SUBJECT: AMENDMENT NO. 131 TO PROVISIONAL OPERATING LICENSE NO. DPR-20:
PRESSURE-TEMPERATURE LIMITS AND LOW-TEMPERATURE OVERPRESSURE
PROTECTION (TAC NOS. 72889 AND 71526)

AMENDMENT TO PROVISIONAL OPERATING LICENSE

Amendment No.131
License No. DPR-20

ATTACHMENT TO LICENSE AMENDMENT NO. 131

FIGURE 3-1

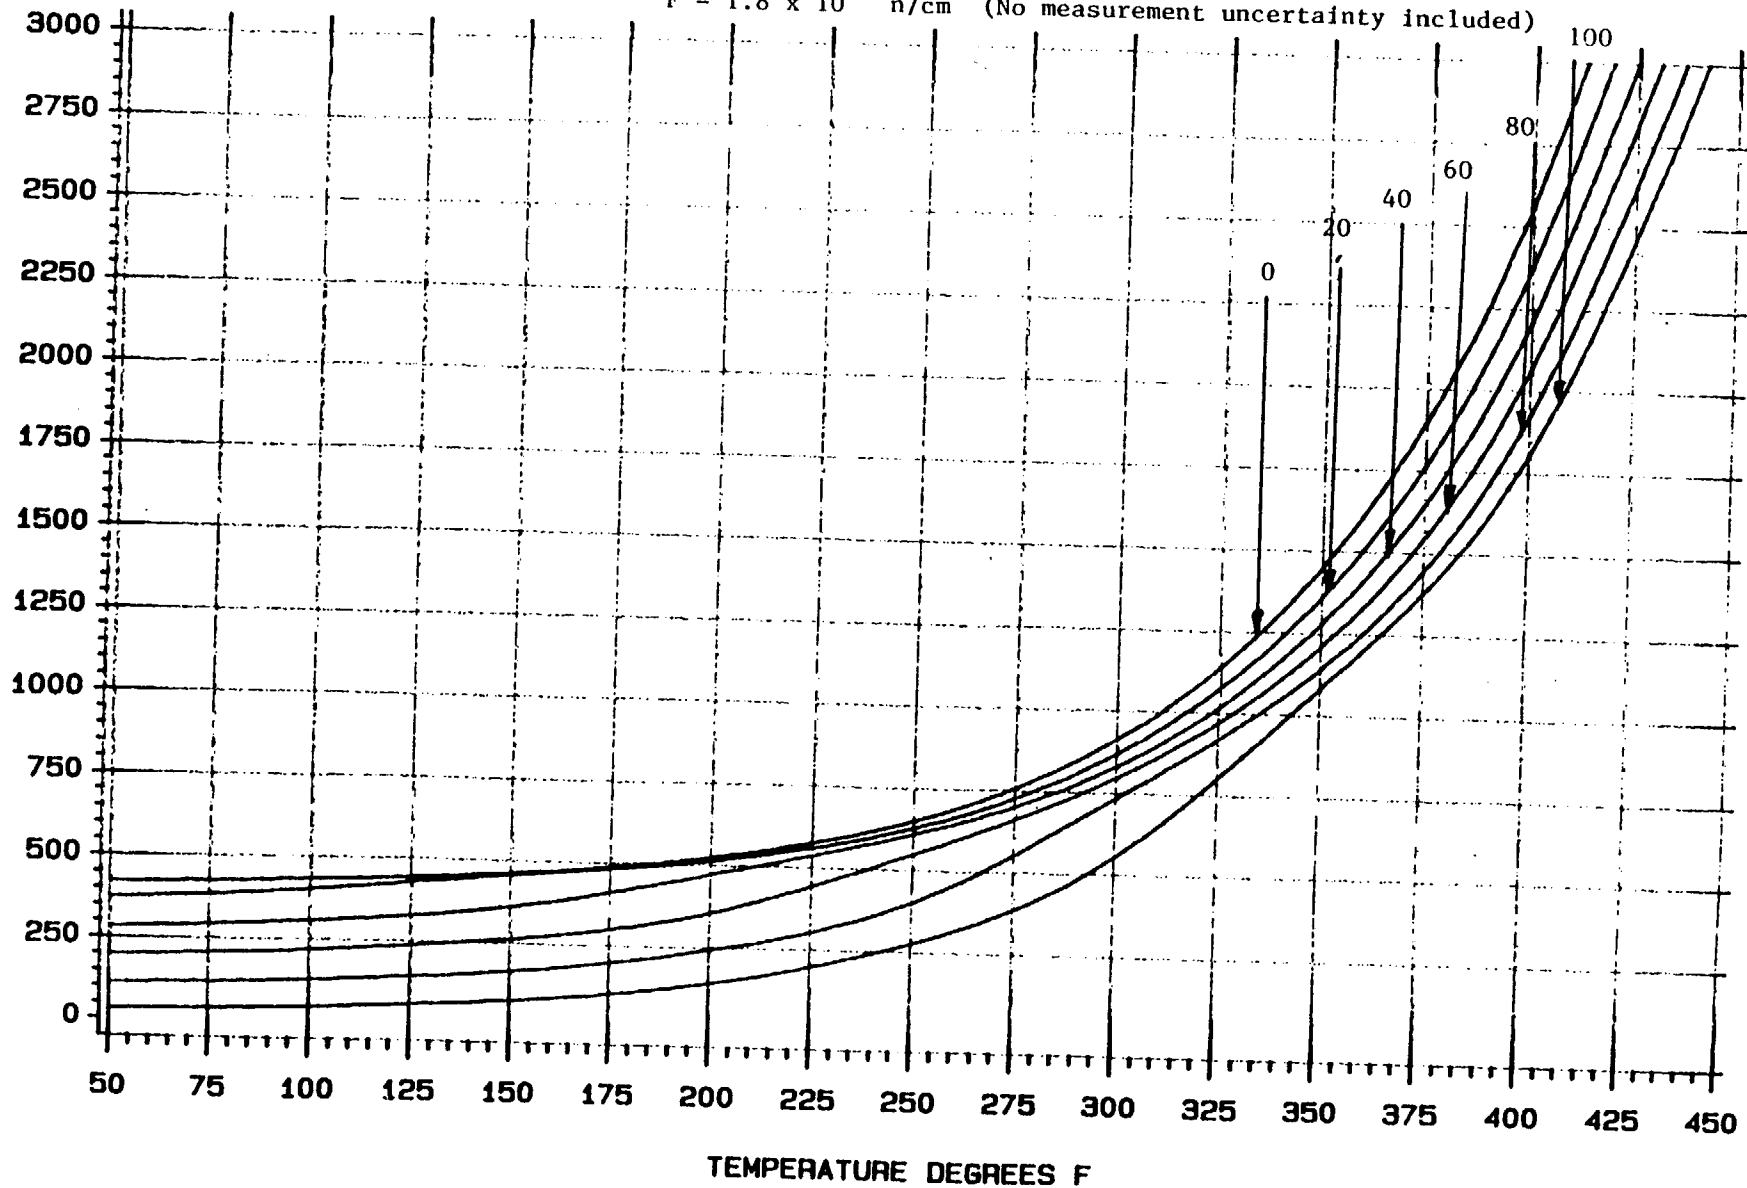
The primary coolant pressure and the system heatup and cooldown rates shall be limited in accordance with Figure 3-1, Figure 3-2 and as follows.

- a. Allowable combinations of pressure and temperature for any heatup or cooldown rate shall be below and to the right of the applicable limit line as shown on Figures 3-1 and 3-2. The average heatup or cooldown rate in any one hour time period shall not exceed the heatup or cooldown rate limit when one or more PCS cold leg is less than the corresponding "Cold Leg Temperature" below.

FIGURE 3-3 PALISADES PRESSURE AND TEMPERATURE LIMITS FOR HYDRO

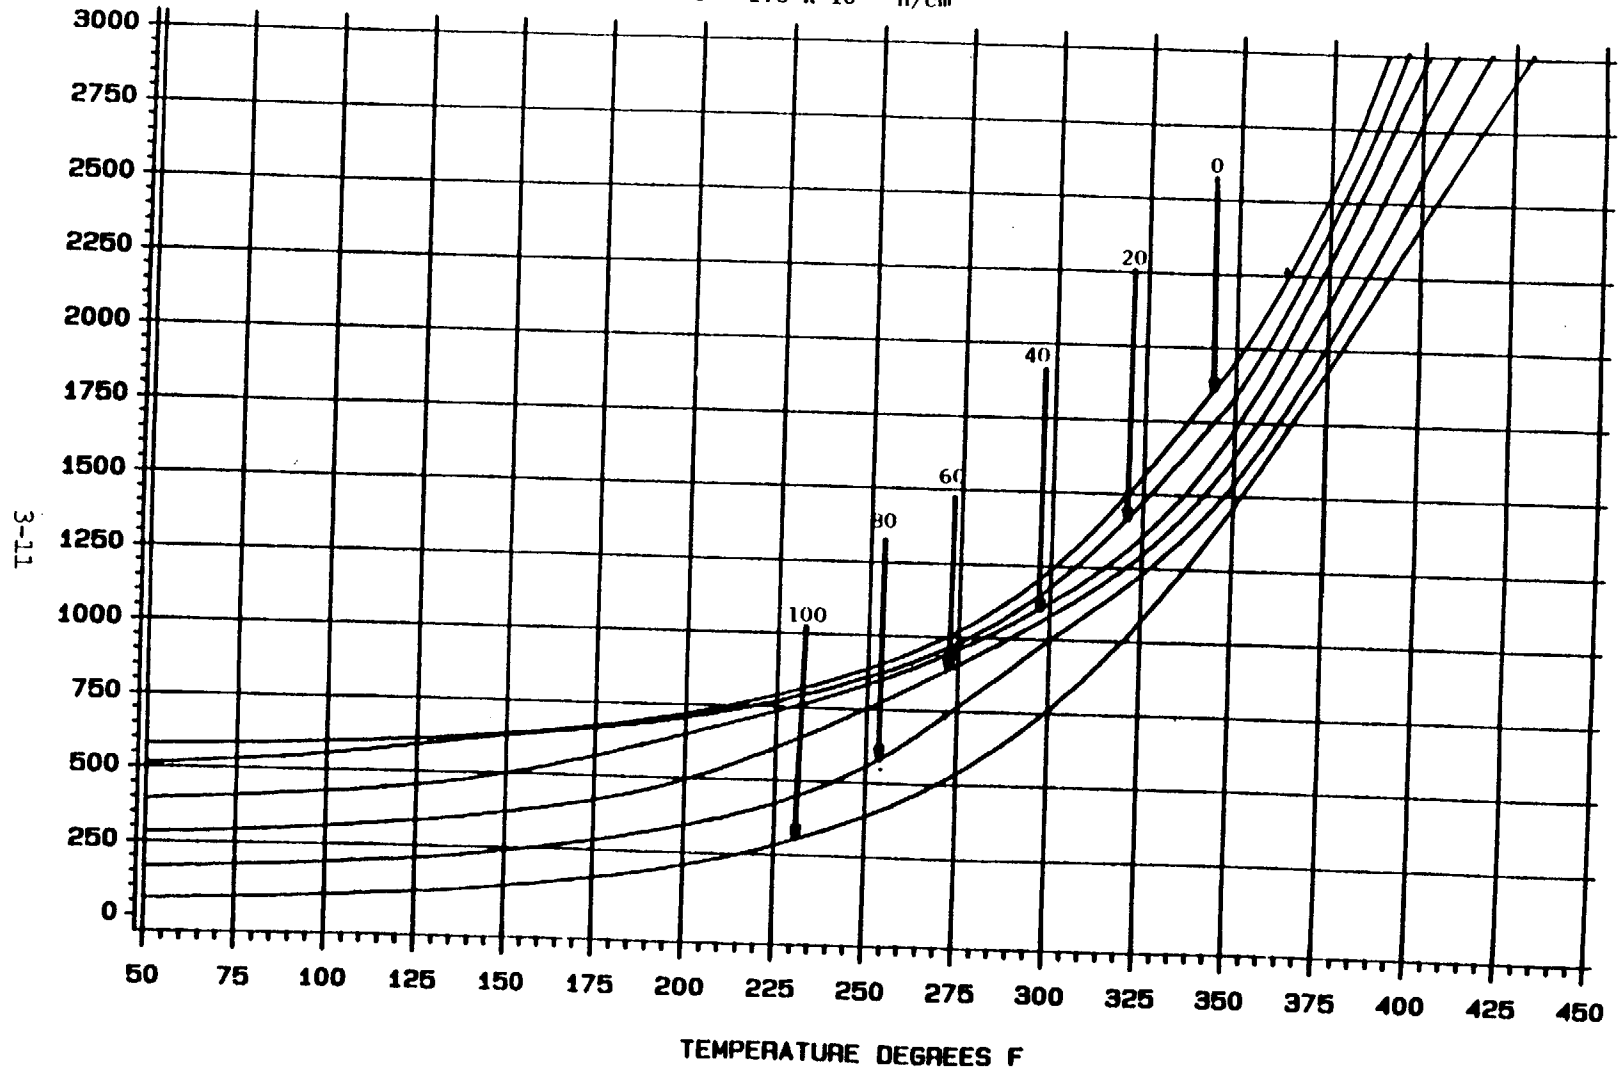
- b. Allowable combinations of pressure and temperature for inservice testing during heatup are as shown in Figure 3-3. The maximum heatup and cooldown rates required by Section a. above, are applicable. Interpolation between limit lines for other than the noted temperature change rates is permitted in 3.1.2a.
- c. The average heatup or cooldown rates for the pressurizer shall not exceed $200^{\circ}\text{F}/\text{hr}$ in any one hour time period. Whenever the Shutdown Cooling isolation valves (MOV3015 and MOV3016) are OPEN, the pressurizer shall not be heated at a rate of more than $60^{\circ}\text{F}/\text{Hr}$.

Figure 3-4

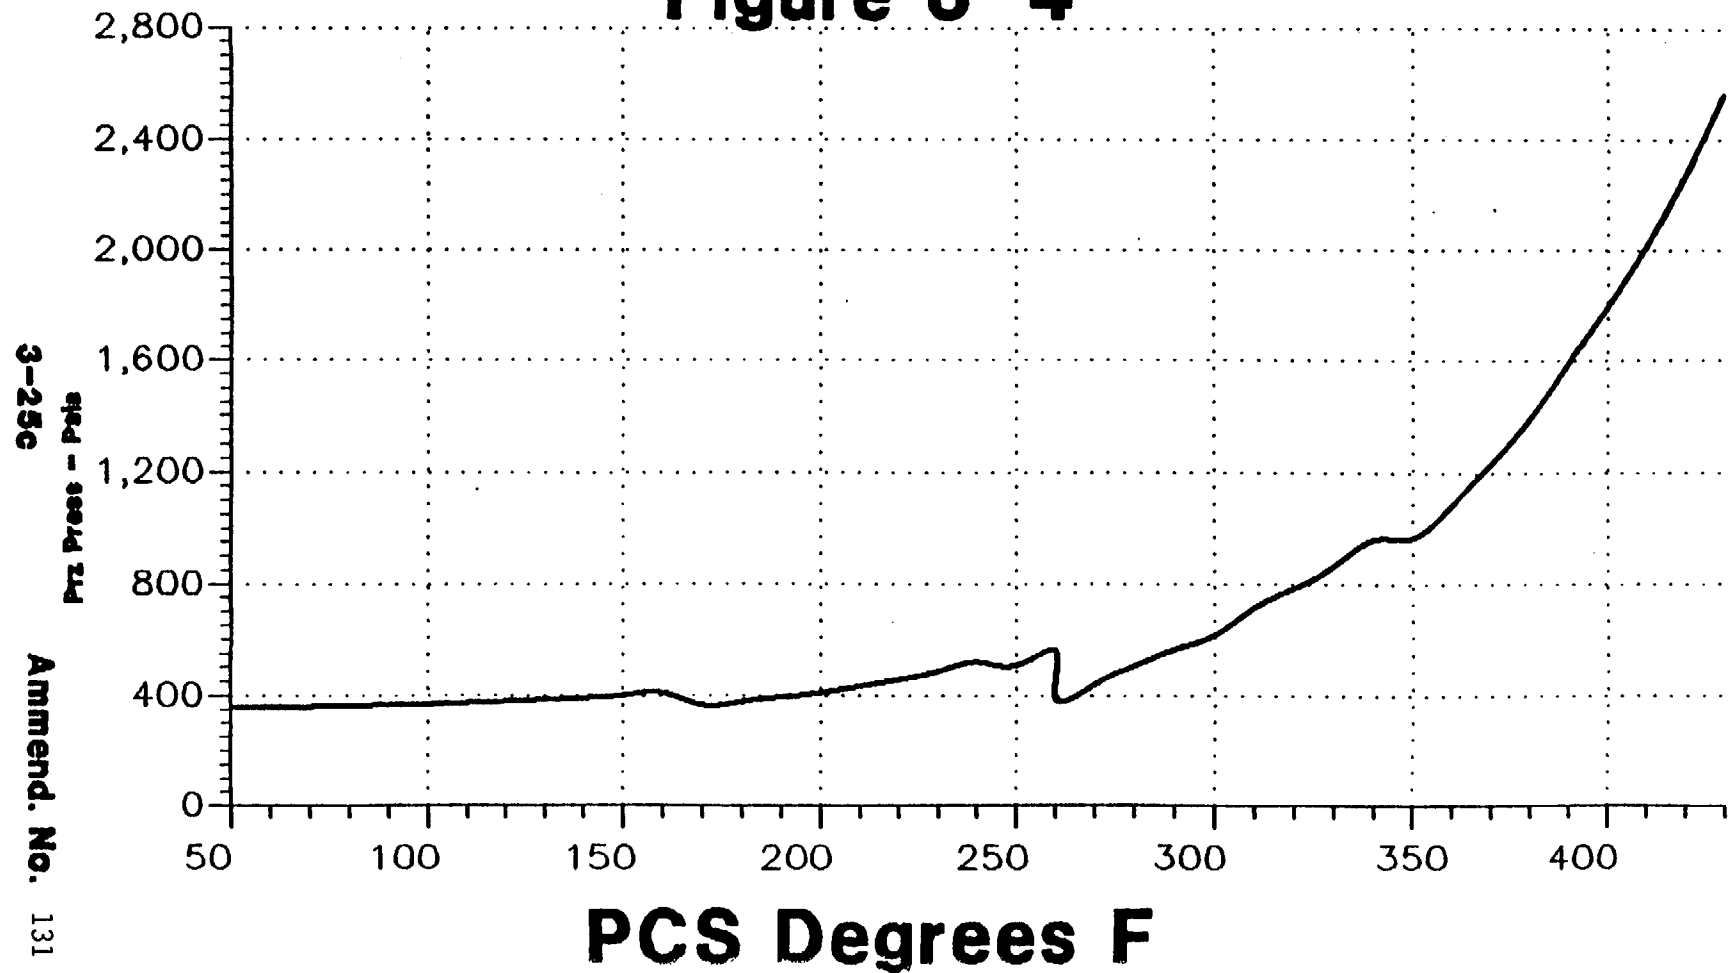
Two power operated relief valves (PORVs) with a lift setting below and/or to the right of the curve in Figure 3-4 shall be operable. /

Assurance that the Appendix G limits for the reactor pressure vessel will not be violated while operating at low temperature is provided by the variable setpoint of the Low Temperature Overpressure Protection (LTOP) system. The LTOP system is programmed and calibrated to ensure opening of the pressurizer power operated relief valve (PORV) when the combination of primary coolant system (PCS) pressure and temperature is above or to the left of the limit displayed in Figure 3-4. That limit is developed from the more limiting of the heating or cooling limits for the specific temperature of the PCS while heating or cooling at the maximum permissible rate for that temperature. The limit in Figure 3-4 includes an allowance for pressure overshoot during the interval between the time pressurizer pressure reaches the limit, and the time a PORV opens enough to terminate the pressure rise. LTOP is provided by two independent channels of measurement, control, actuation, and valves, either one of which is capable of providing full protection. The actual setpoint of PORV actuation for LTOP will be lowered from the limit of Figure 3-4 to allow for potential instrument inaccuracies, measurement error, and instrument drift. This will ensure that at no time between calibration intervals will the combination of PCS temperature and pressure exceed the limits of Figure 3-4 without PORV actuation.
